Access Compliance Report

Public Rights-of-Way

(Curb Ramps)

Intersection ID: 3270	Main Street: BATTLE_CREEK_CT	Cross Street: OLD_TIMBER_RD	Location: W
ADA ID: A9E5EA76ED22	Ramp Type: Perp	Initial Pass/Fail: Fail	Overall Compliance: No
Severity Score: 10			
Codes/Mitigation Info/Possible Solution		Field Measurements/Component Compliance

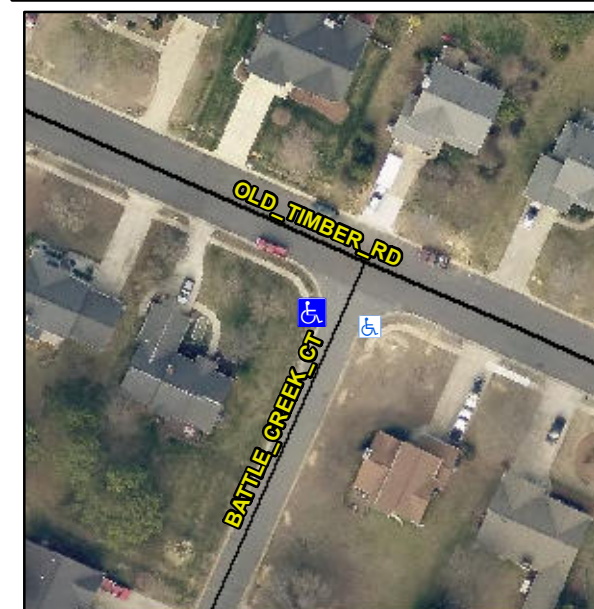
R304.5.1, R304.5.3

Compliance	Description	Data	Compliance	Description	Data
N/A	Ramp Length (in)	56.0	Yes	Ramp Slope (%)	6.8
No	Ramp Width (in)	40.0	No	Ramp XSlope (%)	2.6
N/A	Flare Type LT	N/A	N/A	Flare Type RT	N/A
N/A	Flare Slope LT (%)	N/A	N/A	Flare Slope RT (%)	N/A
N/A	Flare Traversable LT?	N/A	N/A	Flare Traversable RT?	N/A
N/A	Landing Length (in)	N/A	N/A	DWS Provided?	N/A
N/A	Landing Width (in)	N/A	N/A	DWS Contrast?	N/A
N/A	Landing Slope (%)	N/A	N/A	DWS Length (in)	N/A
N/A	Landing X Slope (%)	N/A	N/A	DWS Full Width?	N/A
N/A	Landing Curb? (Y/N)	N/A	N/A	DWS Offset (in)	N/A
N/A	Shared Landing?	N/A			
N/A	Gutter Ponding?	N/A	N/A	Gutter Slope (%)	N/A
N/A	Gutter Lip Ht (in)	N/A	N/A	Gutter X Slope (%)	N/A
N/A	Painted X Walk1?	No	N/A	Painted X Walk2?	N/A
	X Walk 1 Direction	To SE		X Walk 2 Direction	N/A
N/A	X Walk 1 Width (in)	N/A	N/A	X Walk 2 Width (in)	N/A
	X Walk 1 Slope (%)	4.5		X Walk 2 Slope (%)	N/A
	X Walk 1 X Slope (%)	3.3		X Walk 2 X Slope (%)	N/A

Remove & Replace Entire Ramp.
